Proposed Milton Quarry East Extension JART COMMENT SUMMARY TABLE – Natural Environment

JART Comments (December 2022)	Reference	Source of Comment	Applicant Response (Jan 2023)	JART Response (June 2023)
Report/Date: Level 1 and 2 Natural Environment Technical Report (NETR) and Environmental Impact Assessment (EIA) December 2021 Author: Goodban Ecological Consulting Inc. (GEC)

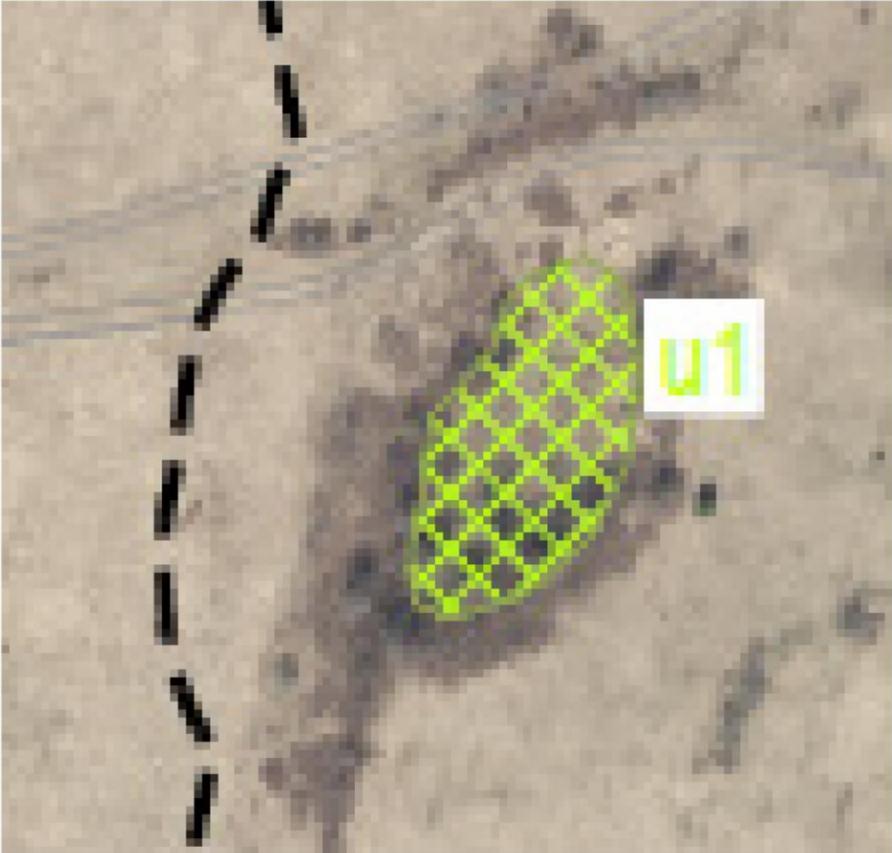
24.	<p>Rehabilitation Plan</p> <p>The rehabilitation plan aims to create a lake, islands and cliffs in place of the current landscape that includes meadow, thicket and small patches of woodland. The restoration is to enhance Niagara Escarpment biodiversity. However, Policy 2.9.11 of the Niagara Escarpment Plan states: Rehabilitation shall incorporate the following:</p> <p>a) natural heritage and hydrologic features and functions shall be restored or enhanced;</p> <p>b) aquatic areas remaining after extraction shall be rehabilitated as representative of the natural ecosystem in that particular setting or ecodistrict, and the combined terrestrial and aquatic rehabilitation shall protect and where possible enhance the ecological value of the site.</p> <p>This policy emphasizes that the proposed rehabilitation should be representative of the existing ecodistrict. However, lakes, shoals and islands are not characteristic features within this Ecodistrict, Ecodistrict 6E-7 (Henson and Brodribb 2006). The following are documented as vegetation types characteristic of this Ecodistrict (Henson and Brodribb 2006):</p> <ul style="list-style-type: none"> • Broad-leaved Sedge Organic Shallow Marsh Type • Bulblet Fern - Herb Robert Open Shaded Limestone / Dolostone Cliff Face Type • Cliffbrake - Lichen Open Unshaded Limestone / Dolostone Cliff Face Type • Dry - Fresh Red Oak Deciduous Forest Type • Dry - Fresh Sugar Maple - Oak Deciduous Forest Type • Dry - Fresh White Oak Deciduous Forest Type • Dry - Fresh White Pine - Oak Mixed Forest Type • Dry - Fresh White Pine - Red Maple Mixed Forest Type • Dry Black Oak - White Oak Tallgrass Woodland Type • Dry Black Oak Deciduous Forest Type • Dry Black Oak-Pine Tallgrass Savannah Type • Dry Herbaceous Limestone / Dolostone Talus 	Section 110	Sarah Mainguy, NSE	<p>The Ecodistrict 6E-7 (Oak Ridges Ecodistrict) is shown on Tab E, Figure 1. This expansive Ecodistrict covers approximately 4,418 km² and the main physiographic feature is the Oak Ridges Moraine, extending eastwards almost to Belleville. Only around 498 km² or 11.3% of the Ecodistrict falls within the Niagara Escarpment. Ecodistrict 6E-7 contains many features that are not representative of the Niagara Escarpment.</p> <p>The list of "vegetation types characteristic of this Ecodistrict" provided by JART includes a number of community types that are either not characteristic of the Niagara Escarpment in general or the Halton Section of the Niagara Escarpment in particular, or are not suitable for incorporation into a quarry rehabilitation plan for various practical reasons. At Tab F, GEC sorted the list of 31 vegetation community types into the following groupings: Forest; Tallgrass Prairie, Oak Savannah and Oak Woodland; Cliff Rim, Cliff and Talus; and, Wetland.</p> <p>For the 12 forest community types listed as characteristic of Ecodistrict 6E-7:</p> <ul style="list-style-type: none"> • There are no White Oak or Black Oak dominated forests in the Halton Section of the Niagara Escarpment; • Red Pine is not native to Halton Region and it is typically associated with conifer plantations, although it will spread by seed; • White Ash is in severe decline due to the Emerald Ash Borer, making this species unsuitable for use in reforestation projects; and, • Most of the forest types listed are later successional or climax communities that are not readily established in reforestation projects or for pit/quarry 	Response accepted – we appreciate the effort that has gone into this thorough reply.

JART Comments (December 2022)	Reference	Source of Comment	Applicant Response (Jan 2023)	JART Response (June 2023)
				<p>al. (1996) includes Appendix A, which is entitled <i>Vegetation Communities of the Niagara Escarpment Biosphere Reserve</i>. Appendix A provides listings of vegetation community types by Escarpment Section, e.g., Niagara, Halton, Dufferin, Grey and Bruce Peninsula. The community classification system used by Riley et al. (1996) predates the <i>Ecological Land Classification for Southern Ontario: A First Approximation</i> (Lee et al. 1998), but there are many similarities between the two. GEC reviewed Riley et al.'s (1996) community types documented for the Halton Section of the Niagara Escarpment; analogs of almost all of the ELC ecosites and community types listed by GEC at Tab G for the MQEE EEP and Rehabilitation Plan are also listed from the Halton Section of the Niagara Escarpment by Riley et al. (1996).</p> <p>One exception is the Dry Tallgrass Prairie Ecosite (TPO1); prairie grasses are to be planted on the islands that will be created. These grass species are native to Halton Region and the intent is to keep the islands relatively open in character, so that the turtle nesting areas to be created will not be shaded out.</p> <p>Other exceptions are the beach/bar and gravel beach communities, associated with the lake feature. These communities provide important habitats for fish and wildlife. The Demo Area in the Main Quarry includes a lake, wetlands, islands, etc., that provide a variety of important habitats for wildlife and fish. For example, in 2021 and 2022, GEC noted breeding Common Loons and Trumpeter Swans, as well as foraging Common Terns, Caspian Terns and Ospreys. The Demo Area has become an important stopover habitat for migrating waterfowl and shorebirds.</p> <p>The islands, beach/bar and gravel beach features proposed for the MQEE Rehabilitation Plan, while not typical of the Halton Section of the Niagara Escarpment, do occur naturally in the Niagara, Grey and Bruce Peninsula sections. They also occur in the Halton Section in association with manmade lakes/reservoirs. The aquatic and wetland vegetation ecosites and communities are representative of the Halton Section, occurring mainly in lakes (e.g., Lake Medad), beaver pond wetlands, etc.</p> <p>For the earlier Milton Quarry Extension and Acton Quarry Extension applications, the agencies pushed Dufferin to create a range of lake-based habitats (wetlands, islands, shoreline features) because they didn't want "deep sterile lakes". That is why the Site Plans for the Milton Quarry Extension and Acton Quarry Extension include such habitat types and features. In order to create similar habitats and to</p>

JART Comments (December 2022)	Reference	Source of Comment	Applicant Response (Jan 2023)	JART Response (June 2023)
				<p>enhance the Cox Tract linkage, fill importation is necessary. As proposed, the importation of soil allows for a greater diversity of features in the rehabilitation plan and resulting landform.</p> <p>In summary, the Rehabilitation Plan primarily includes plant species selections that are typical of the limestone plain above the Niagara Escarpment in this part of Halton Region. The terrestrial communities to be created include new forests and some cliffs, which are characteristic Escarpment features. A key theme in the Ecological Enhancement Plan (EEP) and Rehabilitation Plan is to use plant species that are characteristic of, and complementary to, the Escarpment landscape. There are some exceptions, but these are mainly in relation to the island features that will be created and essentially function as shoreline habitats. The lake feature is an essential part of the rehabilitated condition, to provide passive groundwater support and protect adjacent water-dependent features. The wetlands, shorelines and islands were designed to provide a range of naturalized habitats and features that will increase local biodiversity.</p> <p>In GEC's opinion, the NEP and ROP policies with respect to quarry rehabilitation and landscape compatibility have been satisfied to a high degree.</p> <p>Reference:</p> <p>Riley, J.L., J.V. Jalava and S. Varga. 1996. Ecological Survey of the Niagara Escarpment Biosphere Reserve. Volume I. Significant Natural Areas. Volume II. Technical Appendices. Ontario Ministry of Natural Resources, Southcentral Region, Peterborough, Ontario. Open File Site Report SR 9601. v + 629 pp., vii + 310 pp.</p>

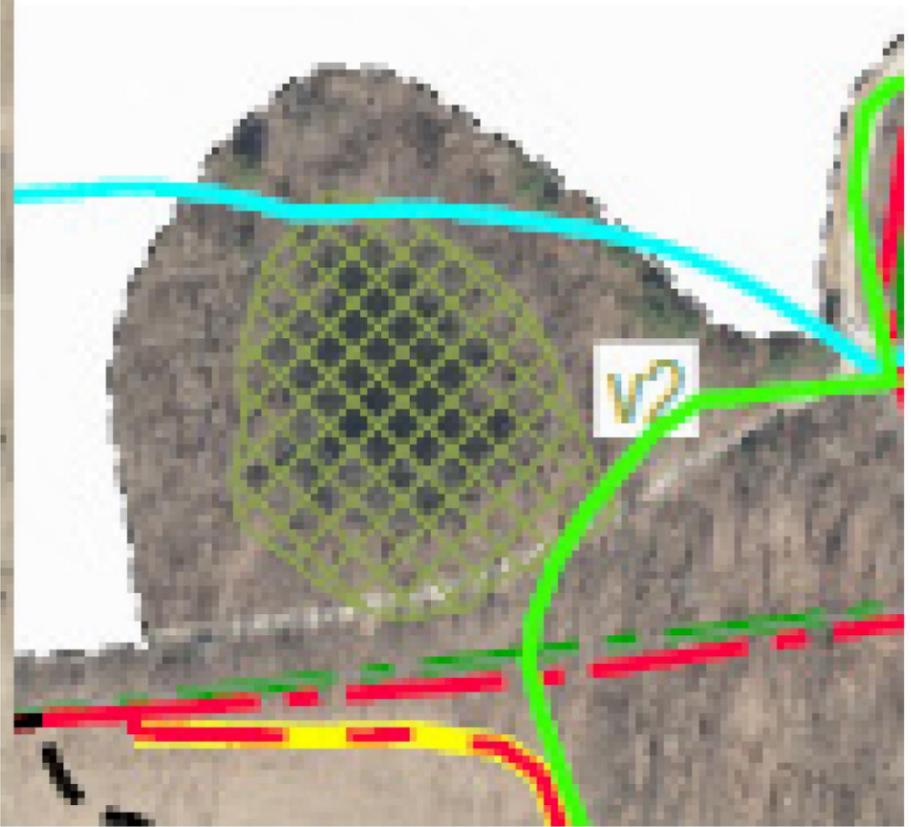
25.	<p>Within the Geology and Water Resources Assessment Report it is stated that some of the key wetlands are within the historic zone of influence of the Main, North Quarry and East Cell. Based on this, the proposed extension may cause additional impacts within its zone of influence, therefore, additional target levels are required, and further mitigation measures may be needed to ensure there will be no negative impacts to the regulated wetlands form and functions.</p>	<p>Level 1 and 2 Natural Environment Technical Report and Environmental Impact Assessment Sections 16.2.1.4 a and 17.4 Cumulative Effects (Pages 169 and 185)</p>	CH	<p>The potential for negative impacts to wetlands if the MQEE proceeds without mitigation measures is clearly recognized in the NETR & EIA, as well as the GWRA. To address this potential for impacts and to enhance the existing condition of certain wetlands, a comprehensive program of mitigation and monitoring is proposed as part of the MQEE Extension, including appropriate additional target levels. It is not proposed to extract the MQEE in the absence of suitable mitigation and monitoring measures.</p> <p>Please also refer to the response provided for Comment #12 in the AMP Addendum Comment Table.</p>	<p>On January 1, 2023, Ontario Regulation 596/22 came into effect. As a result, technical review services for planning and development applications previously provided by Conservation Halton (CH) under Memorandums of Understanding with municipalities (e.g., technical reviews related to natural heritage and select aspects of stormwater management) can no longer be provided.</p> <p>O. Reg. 596/22 does not affect CH's mandatory programs or services. CH has only reviewed this comment based on natural hazard, and wetland matters, per Ontario Regulation 686/21 and Ontario Regulation 162/06.</p> <p>Based on the meetings and discussions held on</p>

JART Comments (December 2022)	Reference	Source of Comment	Applicant Response (Jan 2023)	JART Response (June 2023)
					<p>February 3, 2023, and March 3, 2023, as well as the memo entitled "Supplemental Monitoring Wells and Triggers", dated March 3, 2023, provided for review, CH can confirm this comment has been addressed from a regulatory perspective. We defer any remaining natural heritage related comments to the other JART members to confirm whether it has been addressed.</p> <p>Sarah Mainguy, NSE has reviewed Dufferin's response and provided the following JART response: The response is acceptable (NSE)</p> <p>Norbert Woerns has reviewed Dufferin's response and provided the following comment. The response seems reasonable</p>
